Square Denims Limited (Garments Unit)

1st November 2021

Observations

Material specification in FEM

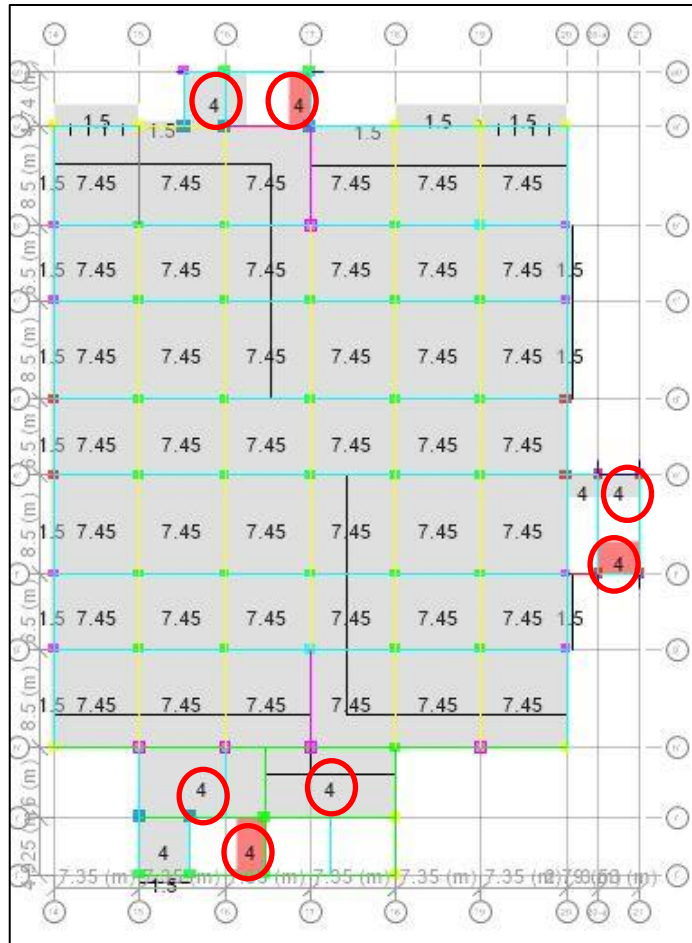
Steel strength has been considered 50 ksi (345 MPa) for canopy, but no material test report has been found regarding that value. Building engineer is required to review the design (either considering minimum grade of steel or verify the steel strength) of the canopy and prepare the design report in compliance with section 1.9.1.1 and section 1.9.1.2 of BNBC.
